Project	IEEE 802.16 Broadband Wireless Access Working Group < <a href="http://ieee802.org/16">http://ieee802.org/16</a> >	
Title	In-band Transparent and Non-transparent Relay Coexistence Frame Structure	
Date Submitted	2006-03-05	
Source(s)	<p>Kanchei (Ken) Loa, Yi-Hsueh Tsai, Yung-Ting Lee, Chih-Chiang Hsieh, Shiann-Tsong Sheu, Hua-Chiang Yin, Frank C.D. Tsai, Youn-Tai Lee, Heng-Iang Hsu          Institute for Information Industry          8F., No. 218, Sec. 2, Dunhua S. Rd., Taipei City, Taiwan.</p> <p>Gang Shen, Kaibin Zhang          Alcatel-Lucent, Research &amp; Innovation          388#, Ningqiao Road, Shanghai, China.</p> <p>[add co-authors here]</p>	<p>Voice: +886-2-2739-9616  <a href="mailto:loa@iii.org.tw">loa@iii.org.tw</a></p> <p><a href="mailto:gang.a.shen@alcatel-sbell.com.cn">gang.a.shen@alcatel-sbell.com.cn</a></p>
Re:	IEEE 802.16j-07/007r2: "Call for Technical Comments and Contributions regarding IEEE Project 802.16j"

# In-band Transparent and Non-transparent Relay Coexistence Frame Structure

Figure xxx Example of in-band transparent and non-transparent relay coexistence frame structure

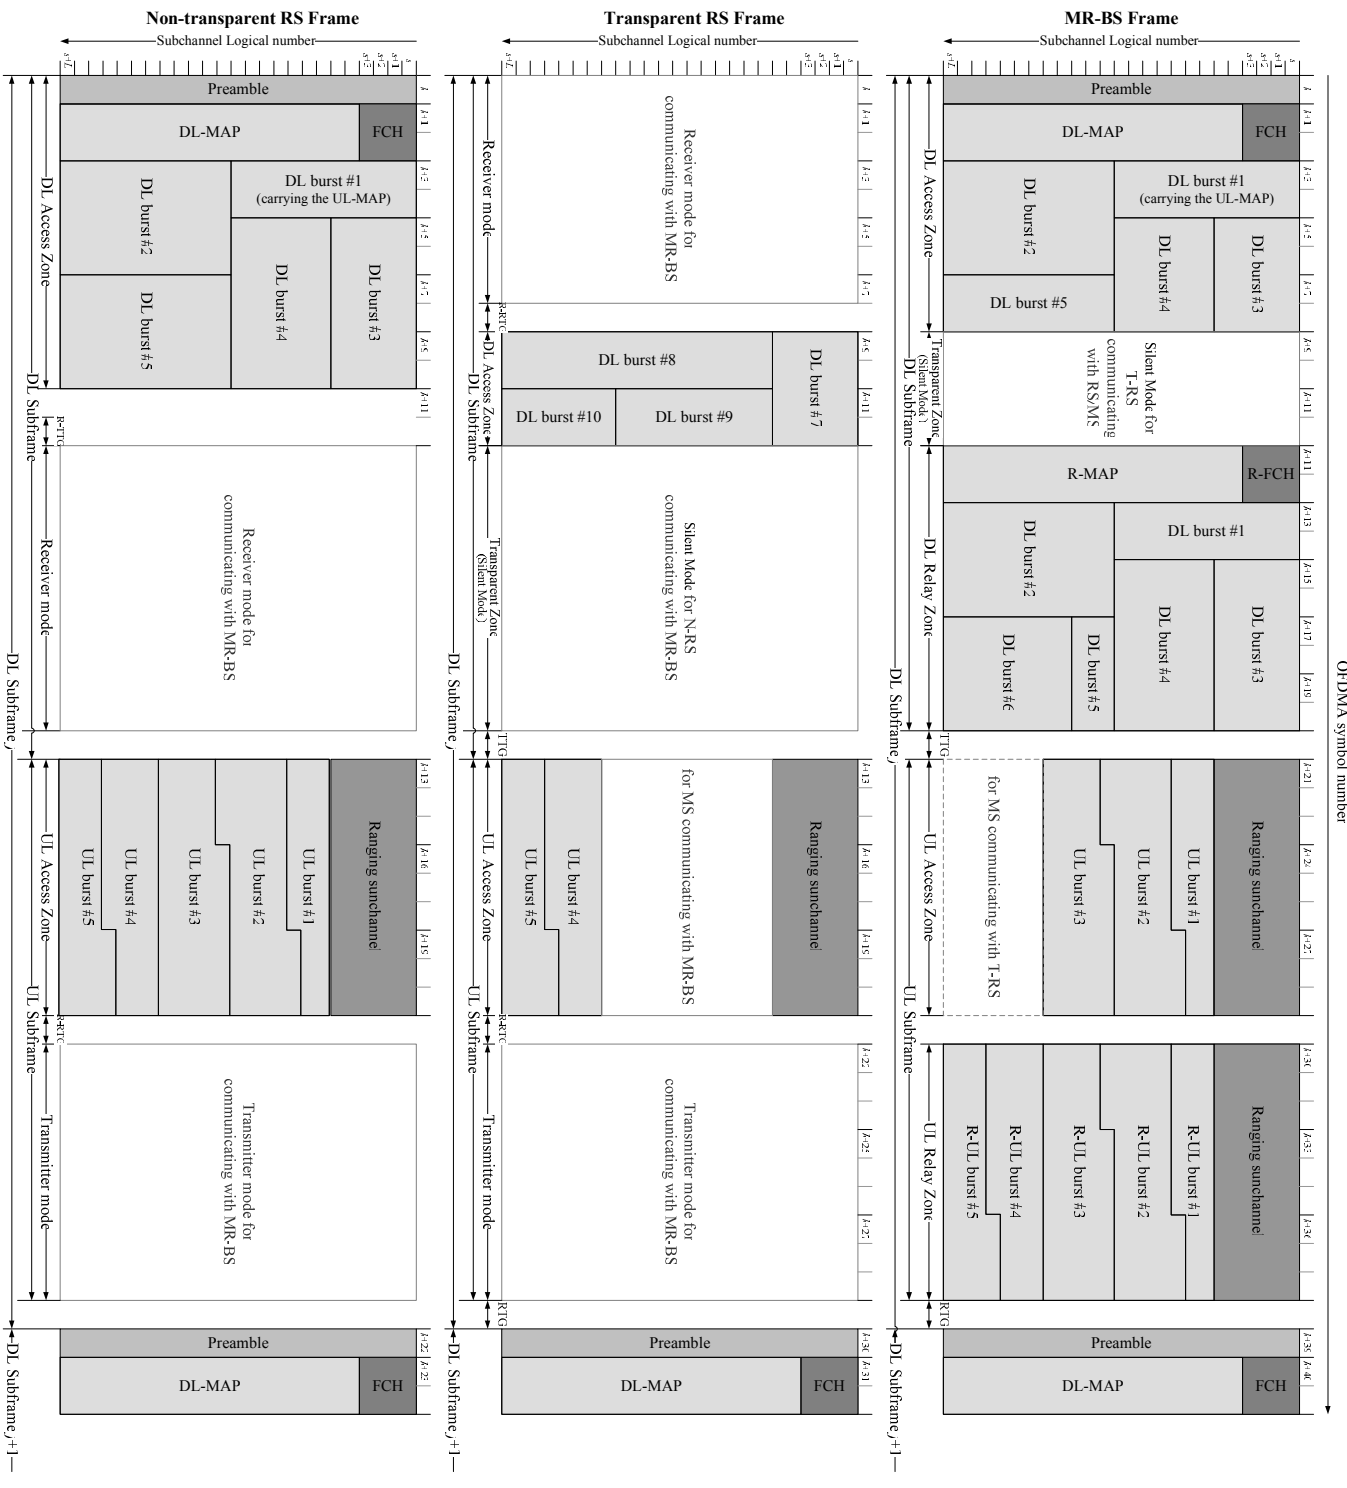
*[Insert section 8.4.4.7.3 “Frame structure for co-existing transparent and non-transparent modes” as indicated:]*

8.4.4.7.3 Frame structure for co-existing transparent and non-transparent modes
